## SYDNEY CENTRAL CITY PLANNING PANEL

PPS-2018SWC081
<b>JRPP No</b>	<b>ADDENDUM TO ASSESSMENT REPORT</b>
<b>Date</b>	24 October 2019
<b>DA No.</b>	DA/469/2018
<b>LGA</b>	City of Parramatta
<b>Proposed development</b>	Construction of a place of worship building comprising a Grand Cathedral, public forecourt space, multipurpose hall and associated basement parking. The application is identified as Integrated Development for the purposes of the Water Management Act 2000.
<b>Street address</b>	163- 165 George Street PARRAMATTA
<b>Property Description</b>	Lot 1 DP 78716, Lot 1 DP 113513, Lot 1 DP 650704
<b>Applicant</b>	The Hellenic Orthodox Community of Parramatta
<b>Owner</b>	The Hellenic Orthodox Community of Parramatta
<b>Recommendation</b>	Approval, subject to conditions of consent
<b>Report by</b>	Tina Christy  City Plan Strategy and Development on behalf of City of Parramatta Council

**Figure 1:** Extract of Northern Elevation (George Street) showing exceedance in building height. (Original Plans)

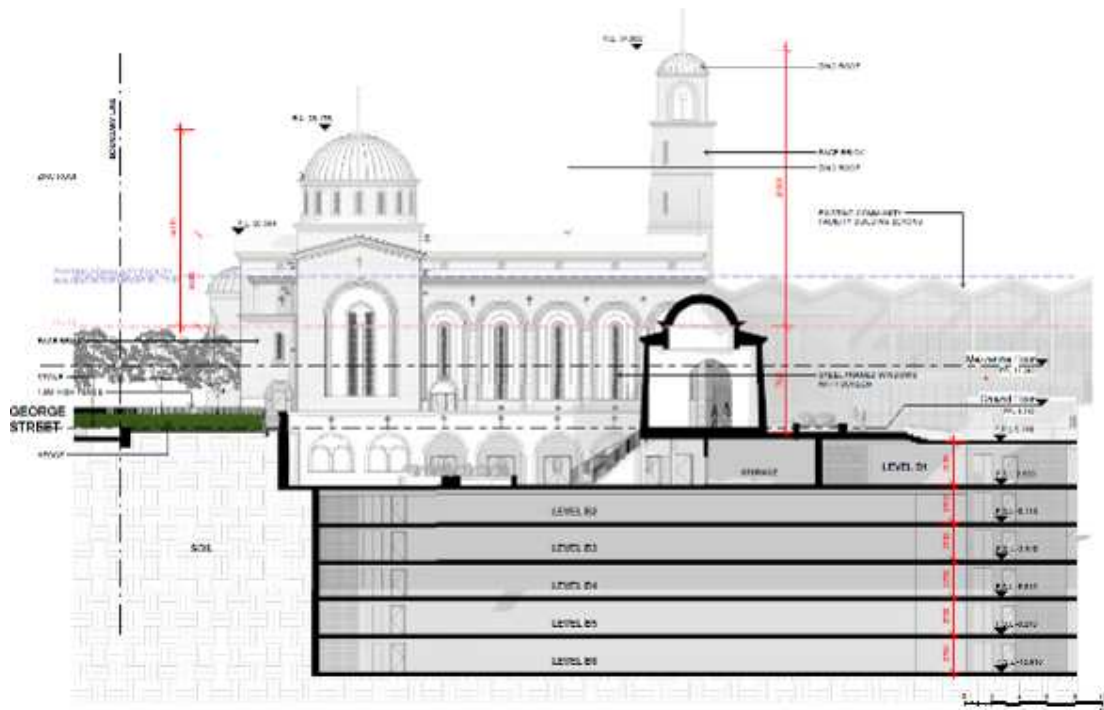
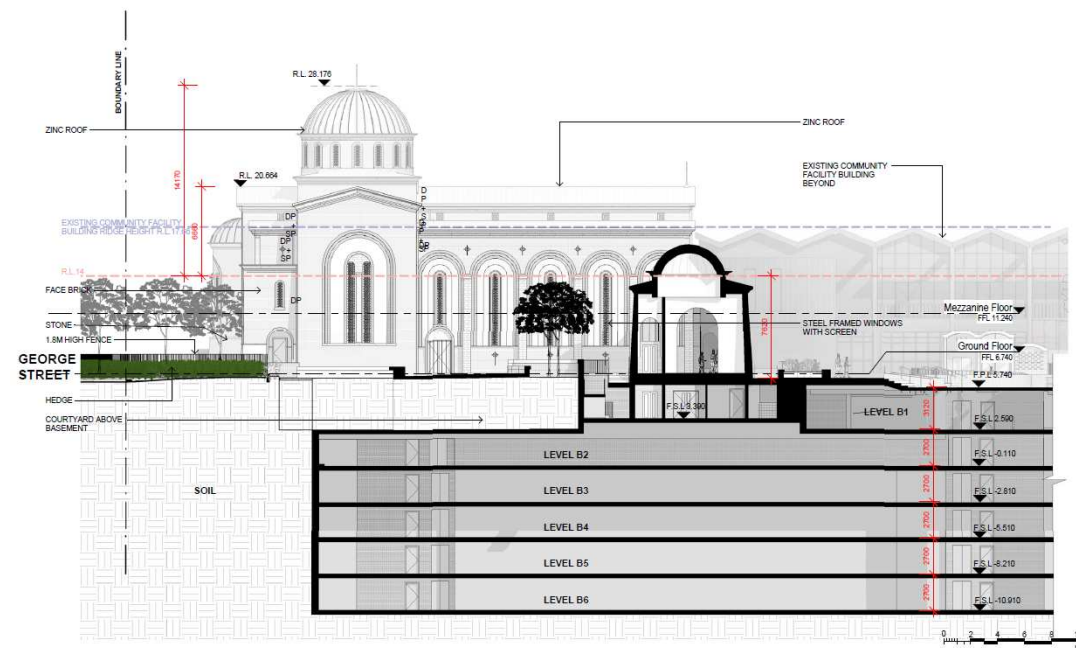
Amendments have been made to delete one tower, thus reducing the maximum height overall. The table below and Figures 1 – 6 show the changes to the height of the proposal.

As can be seen from Figures 1 – 6, the extent of building which now exceeds the maximum height RL 14 is:

- the full length of the building for a height of 6.664m,
- the dome above the north-western corner which exceeds by a height of 3.169m (not including the cross), and
- the dome in the centre of the building which exceeds by a height of 14.176m to top of dome and 15.776m or 112.7% to top of cross.
